# Technical Booklet

**LG Electronics Alabama, Inc.**  
**2023. 10**

# Service Bulletin

## Frost around freezer fan motor

### 1. Repair Instruction

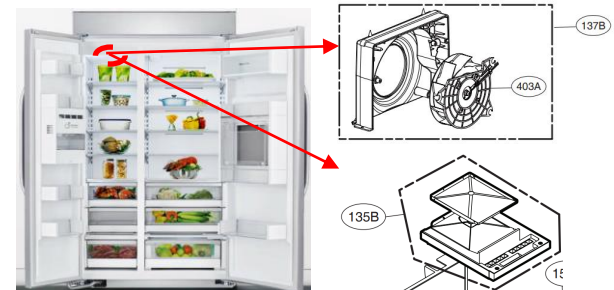
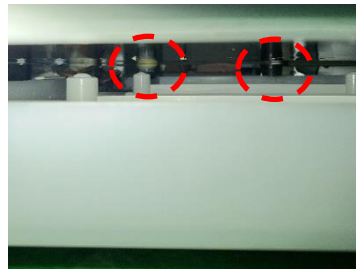
Symptoms	Ice crushing noise such as 'cracking' inside the freezer upper duct multi	<p data-bbox="1246 629 1335 658">Picture</p>  <p data-bbox="1373 735 1590 782">Freezer fan location (inside Freezer Duct, Multi)</p> <p data-bbox="1676 762 1818 809">Freezer fan motor icing defect</p>
Cause	<ul style="list-style-type: none"> <li>- If the drain caps are not installed or if they are deformed, outside humid air flows into the lower side of the Eva, causing fan freezing.</li> <li>- When the freezer door is opened, outside humid air enters and penetrates the insufficiently sealed area of the duct multi top.</li> </ul>

- Check and replace the defrost water drain cap (freezer/refrigerator) at the bottom of the refrigerator.
  - If the Drain Cap [MBL68694701 \(SVC Loc. 630B\)](#) 2 EA is not assembled, remove the product from the cabinet and assemble it from the rear.
- Remove the duct multi at the top of the freezer & check for frost around the fan motor. If icing occurs, remove icing & check the operation of the fan motor.
  - If fan motor operation is abnormal or noise occurs, replace the fan motor [AHV73129804 \(SVC Loc. 137B\)](#) and duct multi [ADJ73232401 \(SVC Loc. 135B\)](#) together.
  - If there is no problem, replace the duct multi only.

## 2. Current and New (Visual / Part number & Name etc)

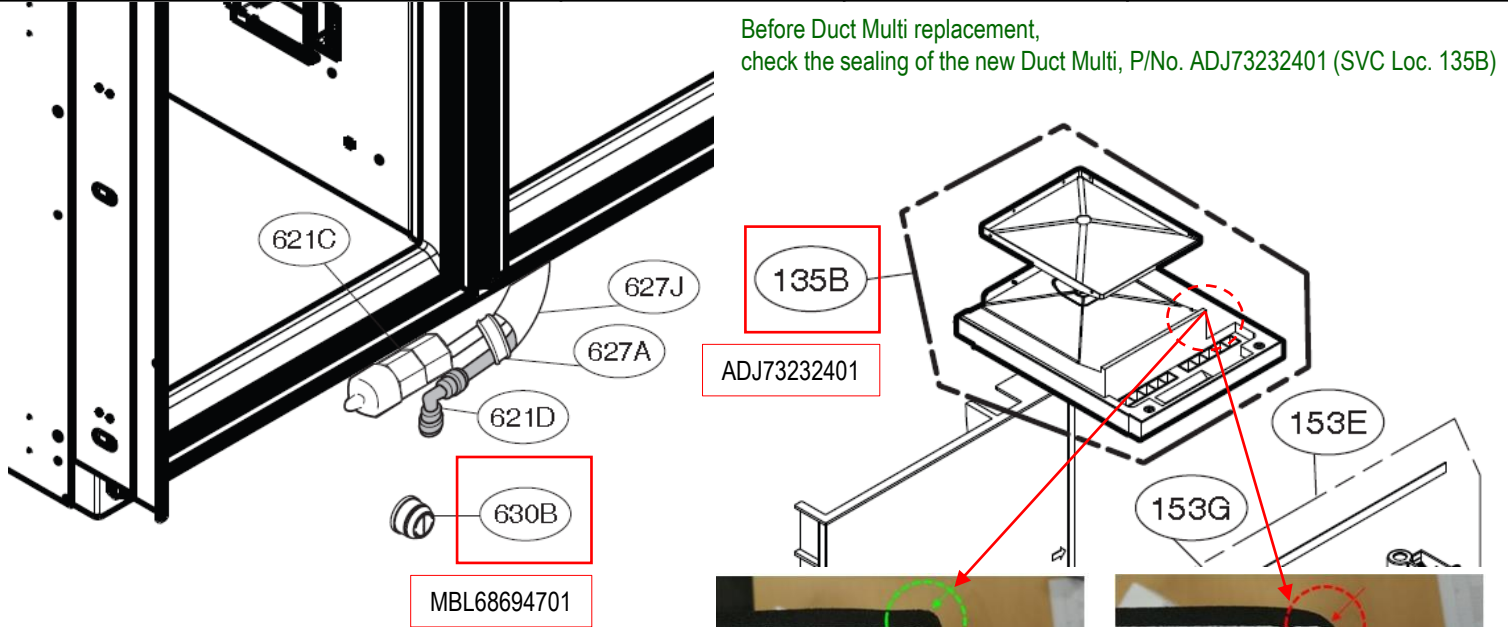
Same part number			
Part Name	Loc No.	As was	Loc No.	Current	Remark
Cap, Drain Tube	630B	MBL68694701	630B	MBL68694701	Shape was improved
Duct, Multi Assembly	135B	ADJ73232401	135B	ADJ73232401	Heater Assembly Position changed

### Repair Instruction

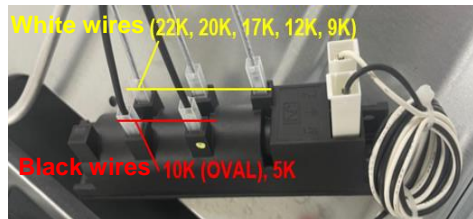
<b>Symptoms</b>	- Top burner not ignite	<b>Picture</b>	
<b>Cause</b>	- Not enough Spark energy

Need to replace Transformer Assembly, Power, Cable Assembly please service as follows

First, confirm the one end of black wire is connected to each spark plug of 5k, 10k(Oval) burners

Connect the other end of **black wire to the lower side (2 – port side)** of the trans, there is no need to distinguish between the 2 ports

Second, **three natural(white) wires** would be connected to the rest **3 ports(upper side)**

Confirm these 3 natural wires connected to the rest three burners among 22k, 20k, 17k, 12k and 9k

**Current and New (Visual / Part Number & Name etc)**

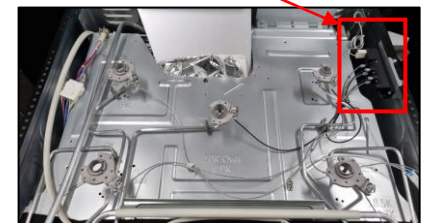
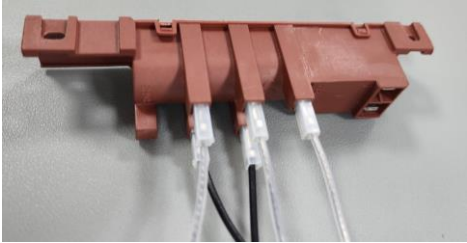
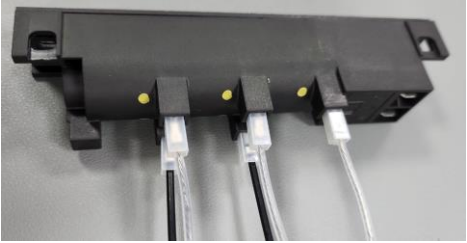
SVC Location	Description	P/No.		Visual	
		Before	After	Before	After
2058	Transformer Assembly, Power,	EBJ62730001	<b>EBJ64465501</b>		
3983	Cable Assembly	EAD65826501	<b>EAD65965002</b>		
3981		EAD65826501	<b>EAD65965005</b>		
3982		EAD65826502	<b>EAD65965006</b>		
				<p>If you use new part for current product, need to change Transformer Assembly, Power and Cable Assembly same time</p>

Current Part	New Part
Current Product	Yes	Yes (Need to change Transformer Assembly, Power and Cable Assembly same time)
New Product	No	Yes
